SUBDIVISION REVIEW SHEET

CASE NO.: C8-2022-0221

SUBDIVISION NAME: River Park South Preliminary Plan

CITY OF AUSTIN –DEVELOPMENT SERVICES DEPARTMENT
SUBDIVISION APPLICATION – MASTER COMMENT REPORT

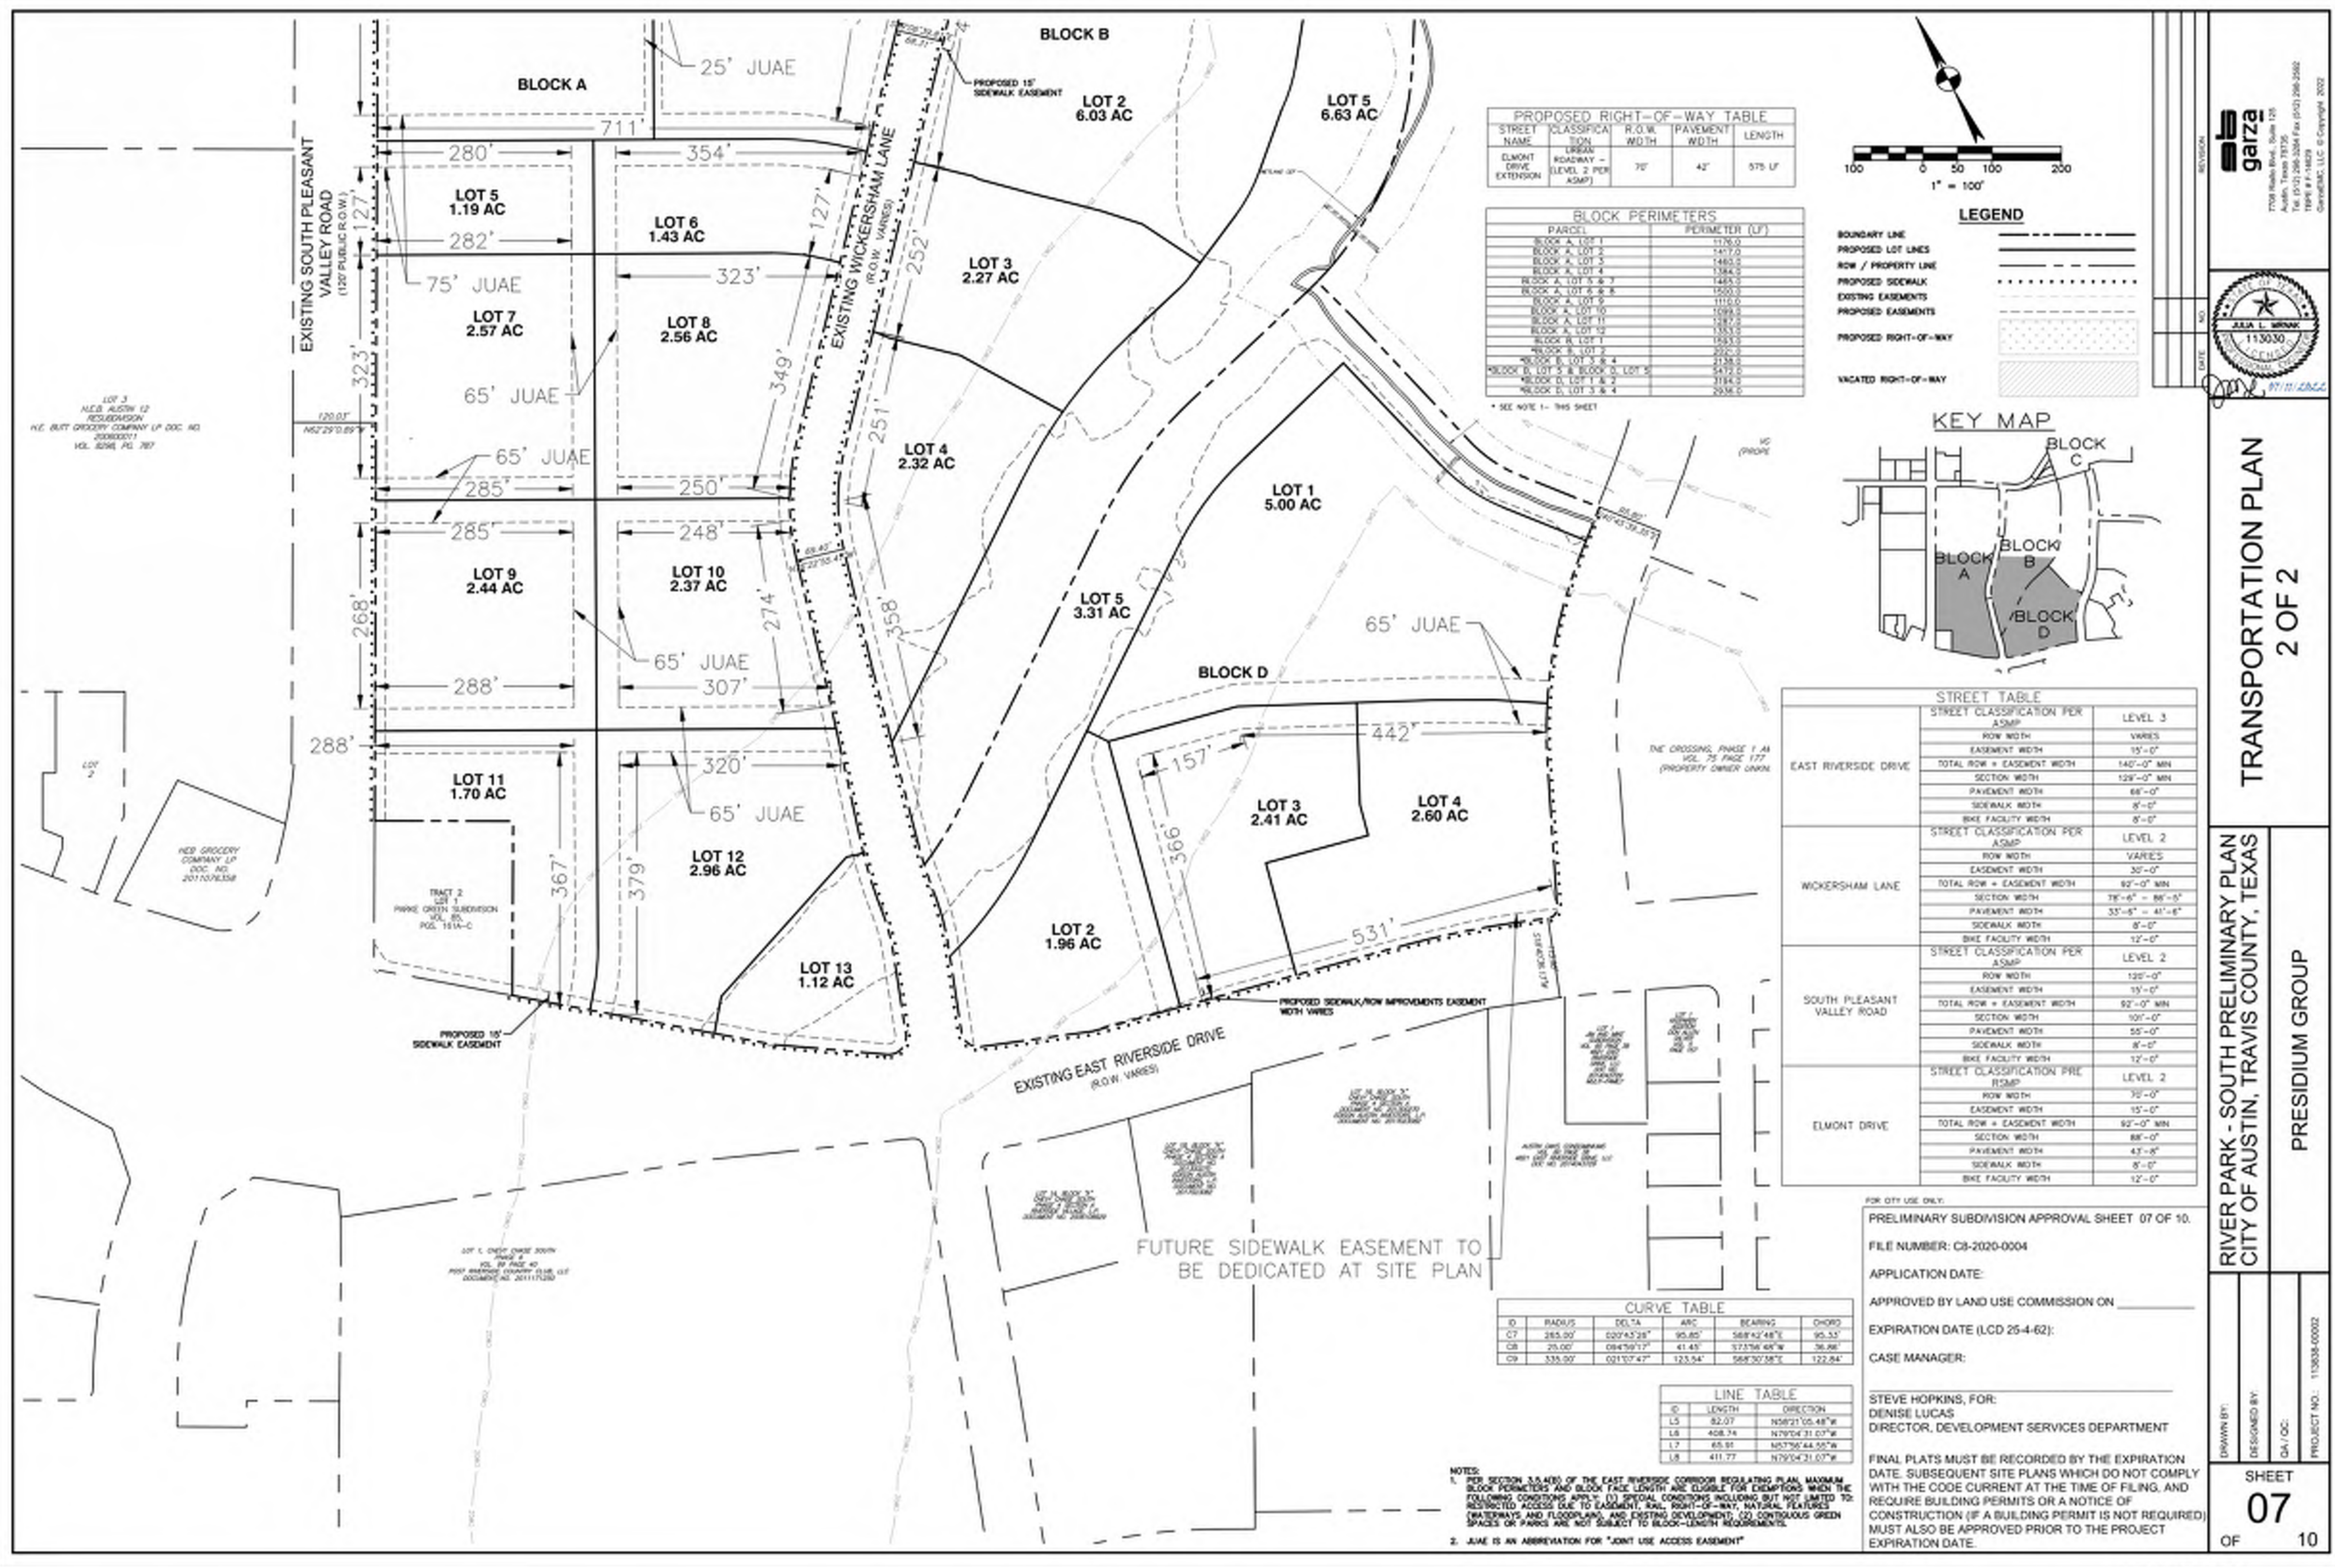
- SR 3. For clarity, remove the following data from sheet 3 "Overall Preliminary Plan" (25-1-83)
- CWQZ
 - Existing floodplain.
 - Existing and proposed easements.
